**PROPOSED DEVELOPMENT:
SECONDARY RESIDENCE**

APPLICATION NO: DA 2024 / 226

Sorell Council
 Development Application: 5.2024.226.1 -
 Response to Request for Information - P4.pdf
 Plans Reference: P4
 Date Received: 28/02/2025

5 CASUARINA CLOSE, PRIMROSE SANDS
 NEW ANCILLARY DWELLING

1
-
STREETSCAPE
1:200 @ A3

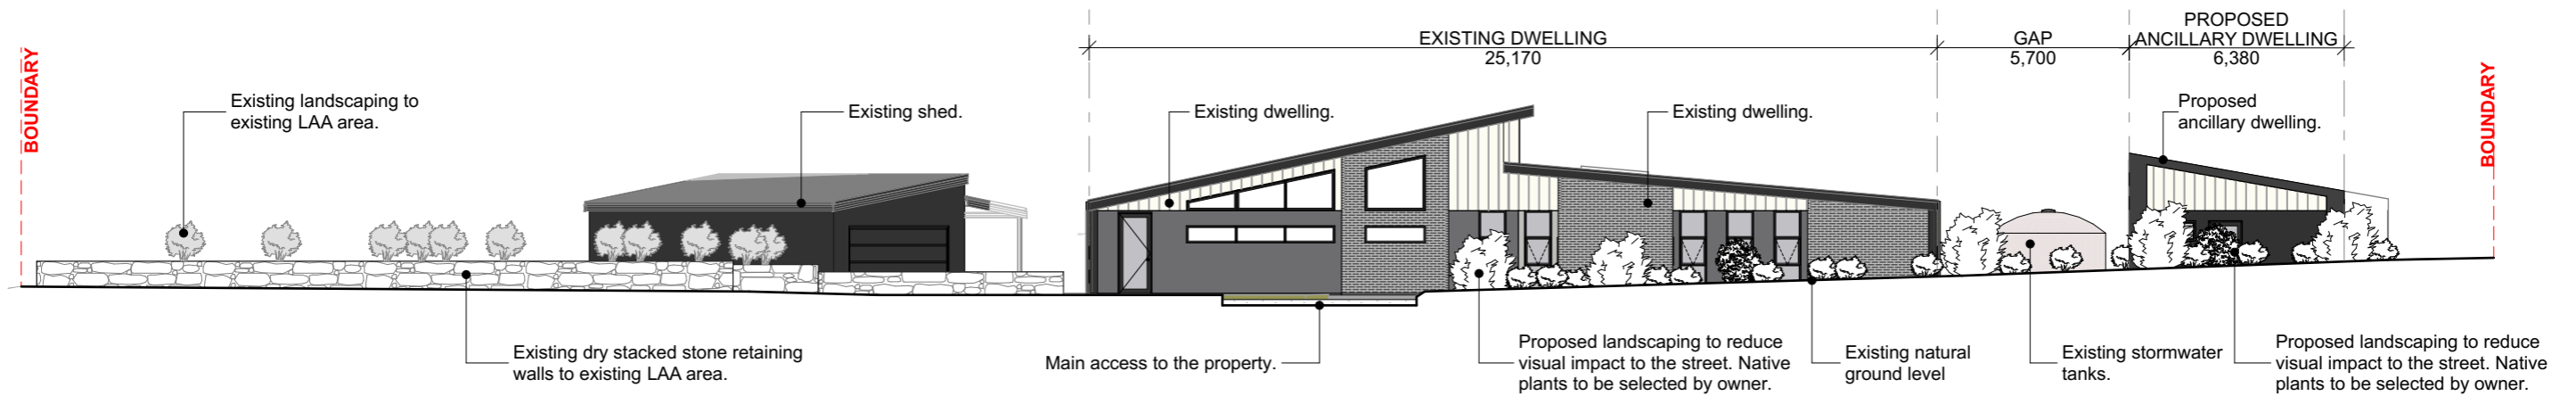
A written statement and associated amended plans that address and responds to the 'Acceptable Solution(s)' or 'Performance Criteria' of the Low Density Residential Zone Clause 10.4.3 P1 & P2 Setback from front, side and rear boundaries and Clause 10.4.4 Site Coverage - Development Standards for Subdivision of the Tasmanian Planning Scheme (TPS).

**Clause 10.4.3 Setback
Performance Criteria P2**

The siting of a dwelling must not cause an unreasonable loss of amenity to adjoining properties, having regard to:

(d) the height, bulk and form of existing and proposed buildings;
MKDD Response - Street scape shows how existing shed, existing dwelling and proposed ancillary dwelling sit along Casuarina Close.

(e) the existing buildings and private open space areas on the site;

Proposed ancillary dwelling will incorporate design features to enhance visual amenity from the street by using a mix of colours, materials, and incorporating openings.

In addition, proposed landscaping will also be incorporated to reduce visual bulk of the site.

MKDD Response - The proposed ancillary dwelling will not cause any adverse impact on the existing buildings or private open space areas within the site.
